**Fir Island Farm Estuary Restoration Project
Interior Drainage Engineering Report
Skagit County, Washington**

November 7, 2014

Submitted To:
Mr. Brian Williams
Washington Department of Fish and Wildlife
111 Sherman Street
LaConner, Washington 98257

**FIR ISLAND FARM ESTUARY RESTORATION PROJECT
FINAL DESIGN AND PERMITTING
INTERIOR DRAINAGE ENGINEERING REPORT
SKAGIT COUNTY, WASHINGTON**

Fir Island Farms Restoration Skagit County, WA	
MODELED SEEPAGE FLUX PROPOSED DIKE - NORTH ZONE	
November 2014	21-1-12318-216
 SHANNON & WILSON, INC. <small>GEOTECHNICAL AND ENVIRONMENTAL CONSULTANTS</small>	FIG. B-10

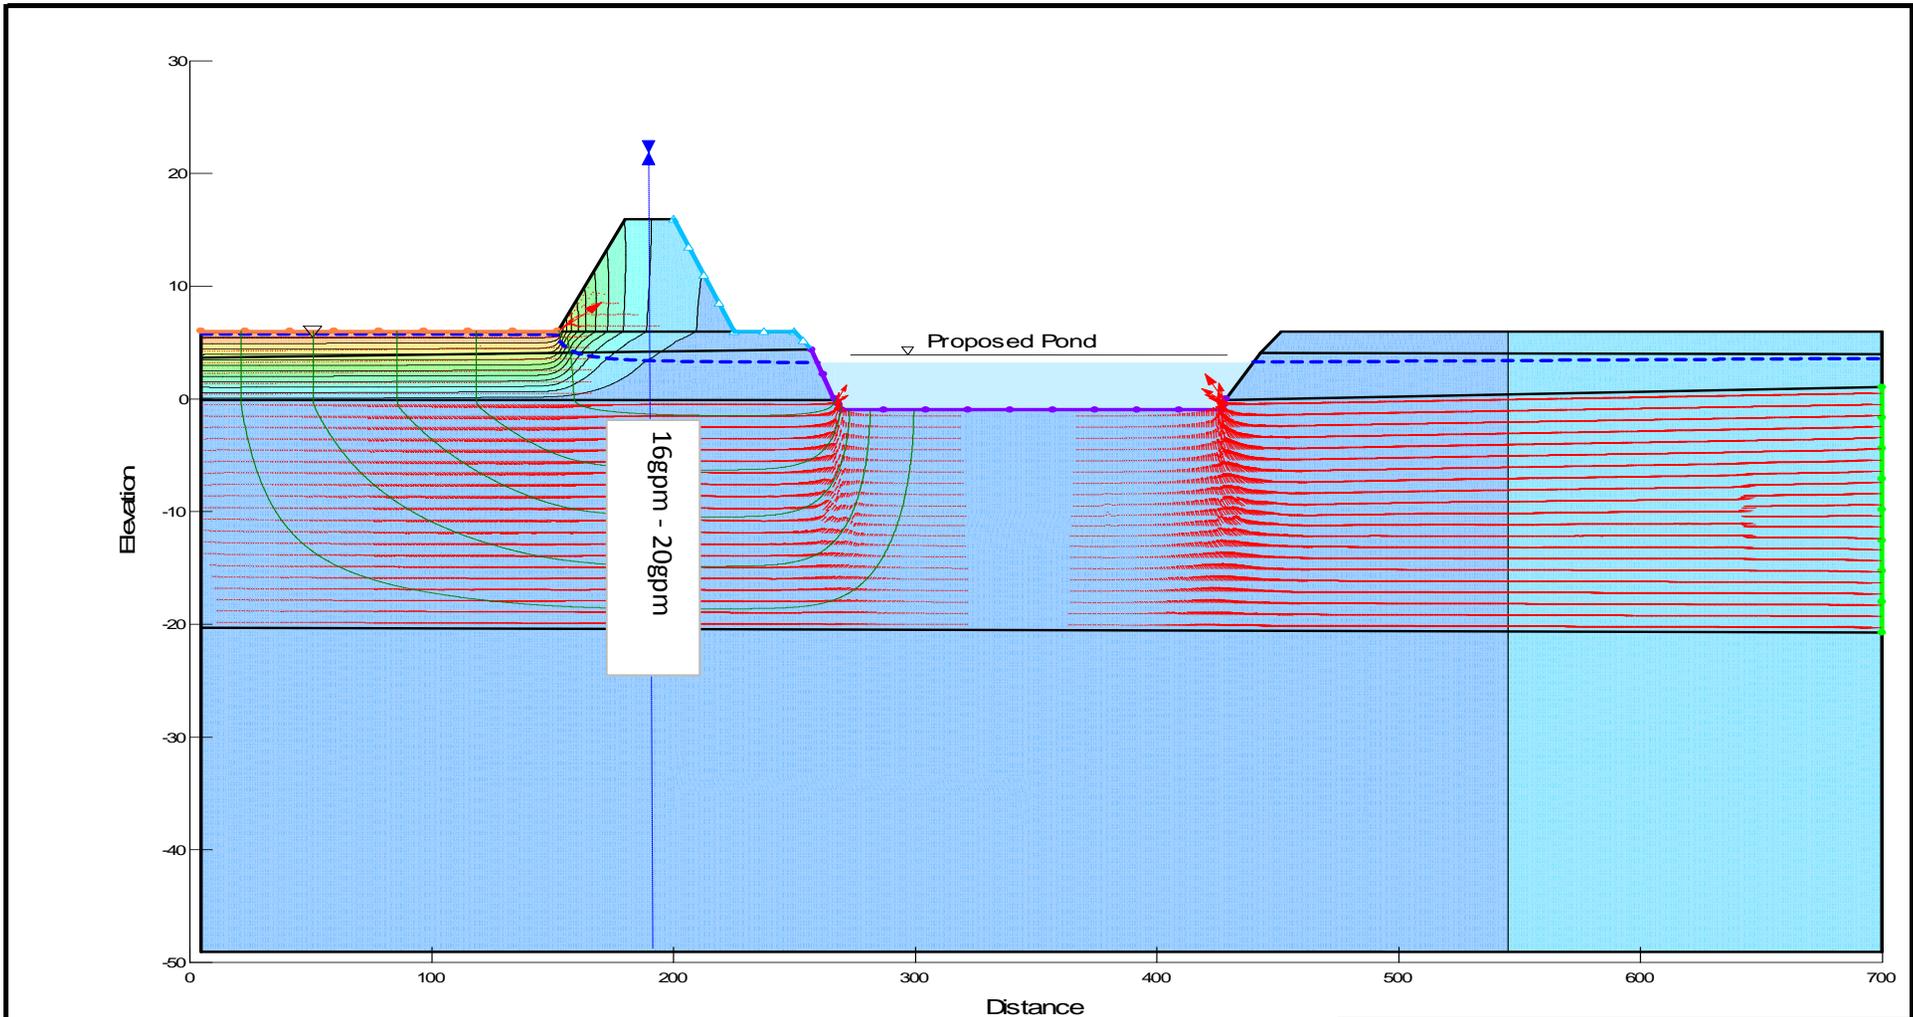
34	Draft Interior Drainage Engineering Report, February 26, 2014	Figure B-10	D. Ladd	Appears incorrectly labeled "West Section"	DRC	Relabeled figure with correct East Zone name.	
35	Draft Interior Drainage Engineering Report, February 26, 2014	Figures B-8, B-9, B-10	D. Ladd	Results from these figures should be identified in the text in the same units as shown on the figures (figures apparently show cfs/ linear foot and text uses total gpm for a length of levee).	DRC	Relabeled figure outputs with similar seepage rates as in text using GPM.

FIG. C-4

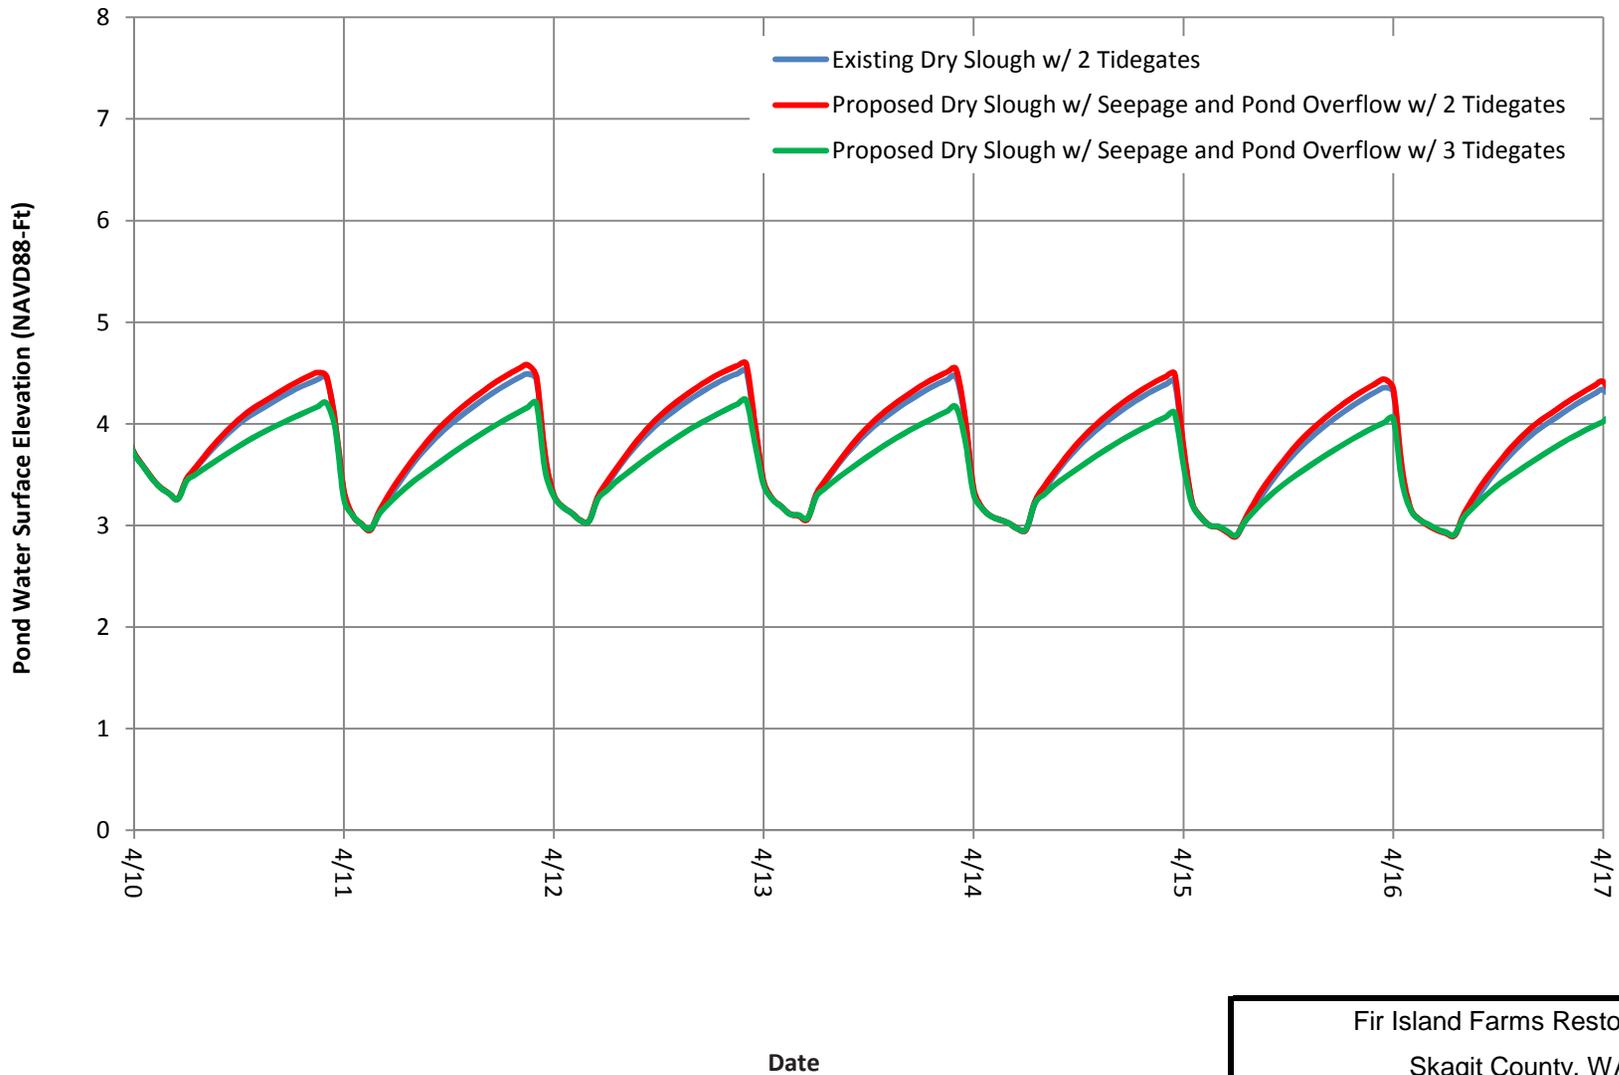
10	same	Figure C-5	Susan Tonkin	How much do the tide gates between the pond and Dry Slough benefit the project if there is a pump station present? Could you add the case of pump station and no tide gates? It isn't clear that it gains the project much in terms of water surface elevations; is it more an issue of reducing pumping costs?	DRC	They save the pump about 0.1 feet of head. CDD 22 has requested inclusion of tidegates for operational flexibility of drainage system
